APPEAL SUMMARY

Status: Decision Rendered - Reconsideration of ID 27601

Appeal ID: 27668	Project Address: 1735 E Burnside
Hearing Date: 4/13/22	Appellant Name: Thomas Ellicott
Case No.: B-008	Appellant Phone: 5035488674
Appeal Type: Building	Plans Examiner/Inspector: Catherine Heeb
Project Type: commercial	Stories: 3 Occupancy: A-2 Construction Type: V-B
Building/Business Name: Gold Record Hi-Fi Bar	Fire Sprinklers: Yes - full building
Appeal Involves: Alteration of an existing structure, Addition to an existing structure, Reconsideration of appeal, occ Change from Mixed B-R2 to A2	
LUR or Permit Application No.: LU# 21058141 DZ	
Plan Submitted Option: pdf [File 1] [File 2] [File 3] [File 4] [File 5] [File 6] [File 7] Proposed use: Nightclub

PROJECT NAME:
GOLD RECORD Hi-Fi BAR
1735 EAST BURNSIDE
CORNER OF: E. BURNSIDE AND SE 18TH AVE.

A2.6

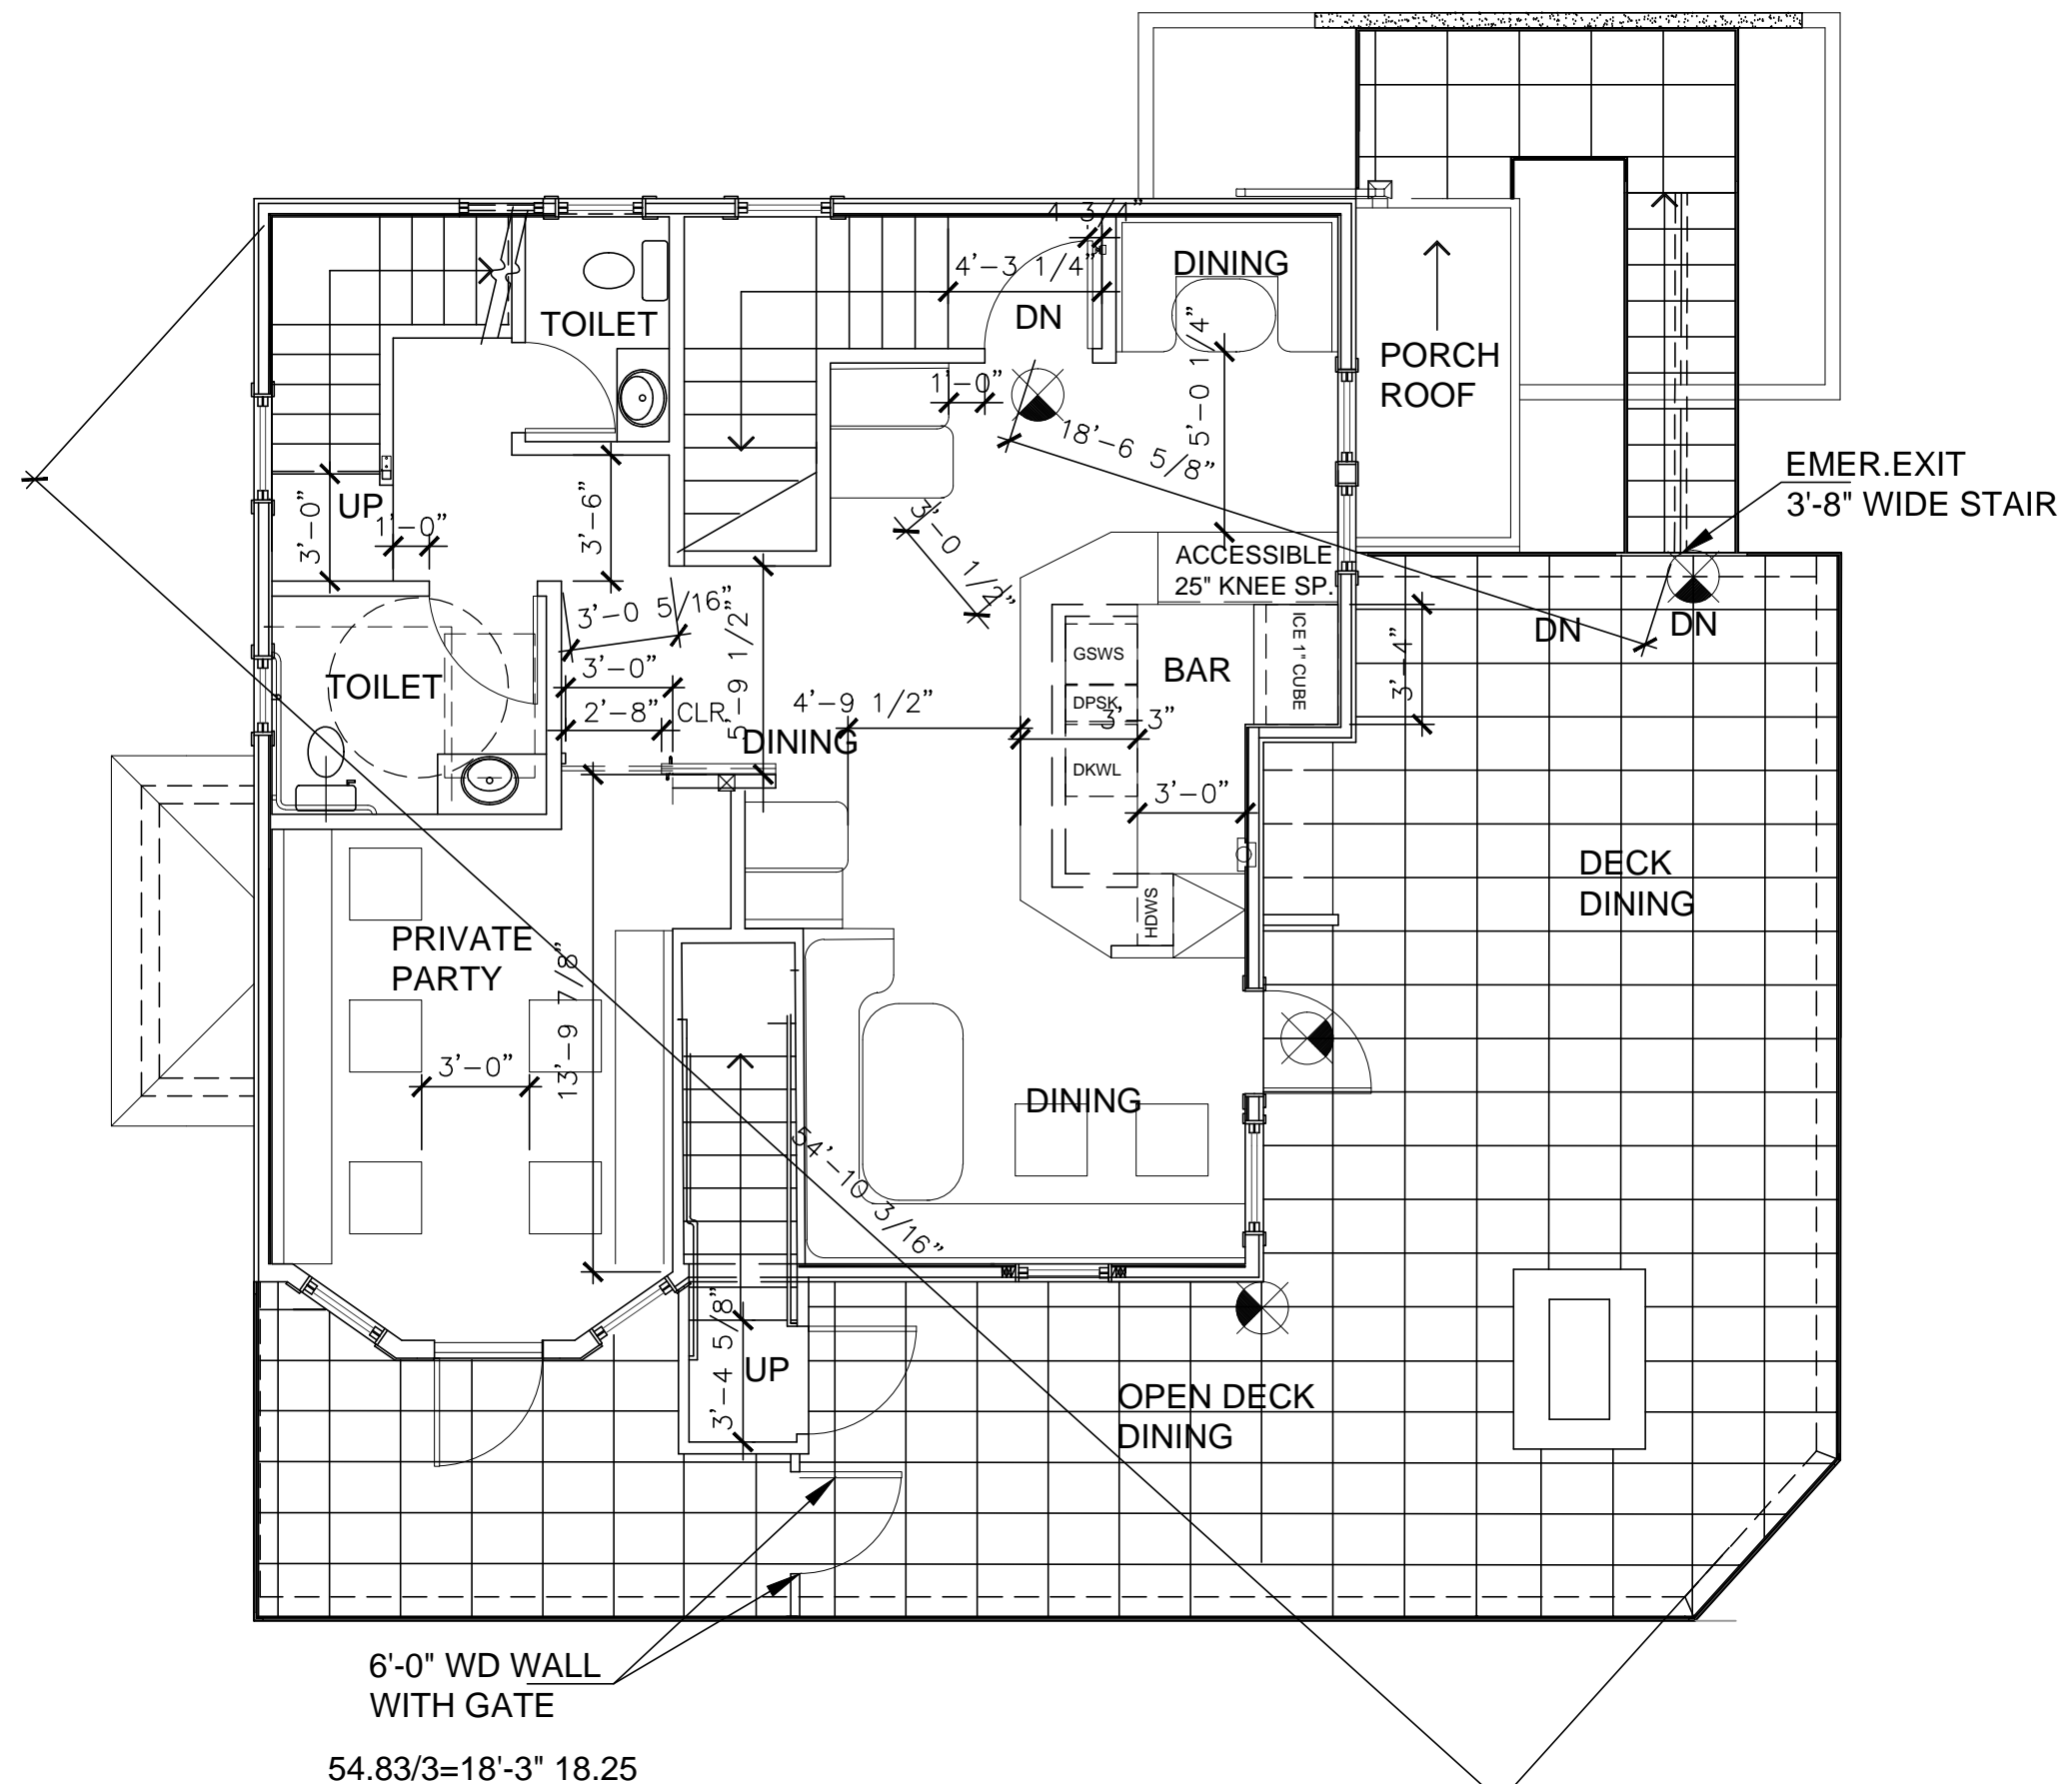
Code Modification or Alternate Requested The intent of the appeal is to show that the exist discharge is exiting to the outside of the building, that the required width (1005.3.1) does not exceed 50% of the discharge's width, and the discharge is a direct path of egress travel to grade connecting the public way.

Proposed Design It appears that the OSSC reviews this Section with the idea that in an emergency event the occupants on the first floor will remain in the building until the people from the 2nd and 3rd floors arrive on their level before leaving the building. Because of this idea a convergency on the exit porch and exit-passage requires the following evaluation method for equivalent safety. The equivalent of the exit width is: 3rd flr-4p(.5)= 2occ, 2nd flr-82p(.5)= 41occ, 1st flr-64p(.5)=32occ. Total occupant passage width at 2+41+32=75(.3) = 22.5inches and exit passage width is 51" (.5)=26" therefor not exceeding 50 percent exit passage width. The exterior deck stairs and path width is: 41(p)people(.3)=13" is less than 50% of 42"(.5) = 21" The deck has two exits, people can inter the building because are the same activity. Additional safety for the exit discharge is by making the walls that enclose the open air passage rated 2hrs (WP8415 or ULU301) for the 10-foot distance to the public way. Installing 2 side wall fuse-link sprinkler heads in the south exterior wall (Exception 1.3) will be added. The 20 SF porch landing is sprinklered and rated 1hr. Emergency lighting is already require in the porch and will be installed in the exit discharge.

3. Exit discharge to exterior of building. Denied. Proposal does not provide equivalent Life Safety protection.

SHEET No.
A2.7

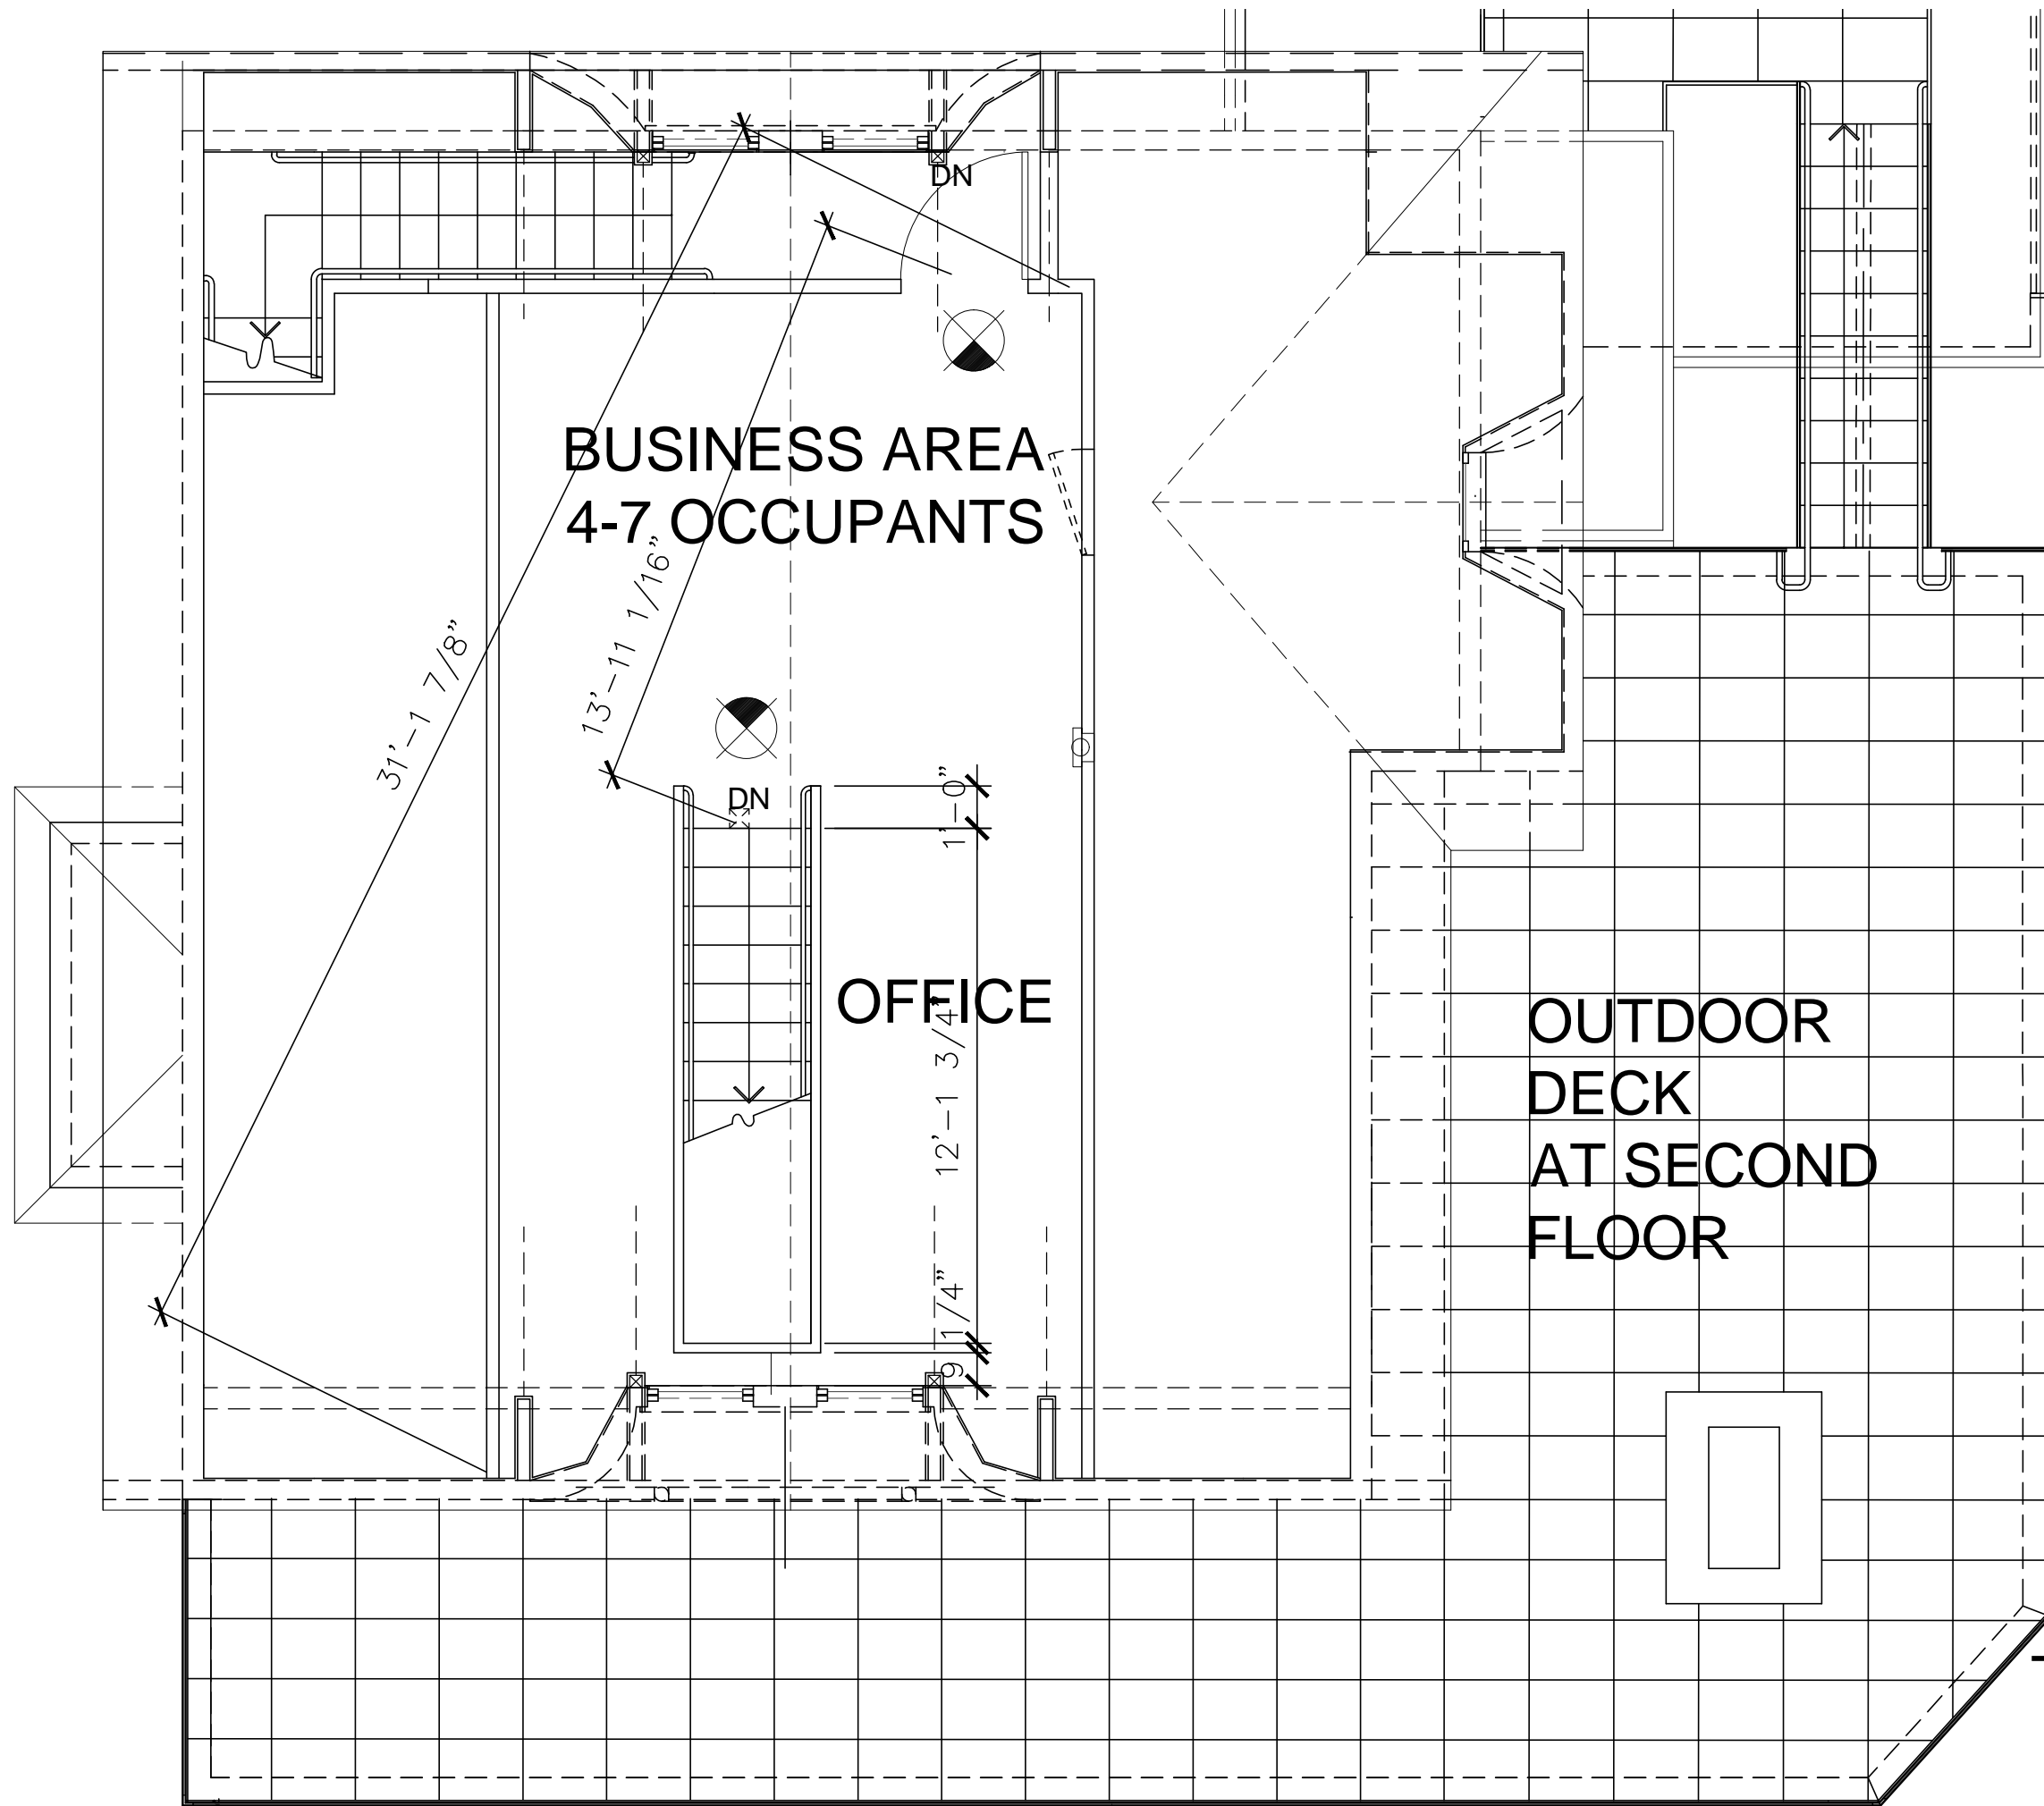
Reason for alternative	<p>The interior stair from the second floor to the first floor has installed materials making it 1-hr. rated required by table 508.4. A 13 foot exit passageway is needed for the stair to exit the building. All doors into the stair and passage way are rated 1-hr and have door closers. Magnetic hold opens are installed on the 2nd floor and first floor doors with panic hardware on the access side of the door latch.</p> <p>The 3rd floor office space creates a mixed occupancy building. The 3rd floor stairs do not connect to the interior stair shaft, half the 3rd floor people can enter the 2nd floor interior stair shaft. Section 711 should not apply to this passageway, however out side the building from this exit is a 9-foot open air passage to the public way sidewalk. If required we will install 2 hr. walls both sides</p>
-------------------------------	--

The corner window in the passageway wall receives two layers of 5/8" type X gypsum board with black out mineral wool insulation to close off the interior wall. The toilet rooms accessed through the passageway and are not considered normal occupied space. However, in a nightclub they will be frequently occupied. Horn strobes with smoke detection provides early warning. The toilet rooms exhaust goes to the north exterior wall, no penetrations pass through the stair or passageway. Emergency lighting is provided in stair and passageway.

2. Exiting from 2nd floor: Denied. Proposal does not provide equivalent Life Safety protection.
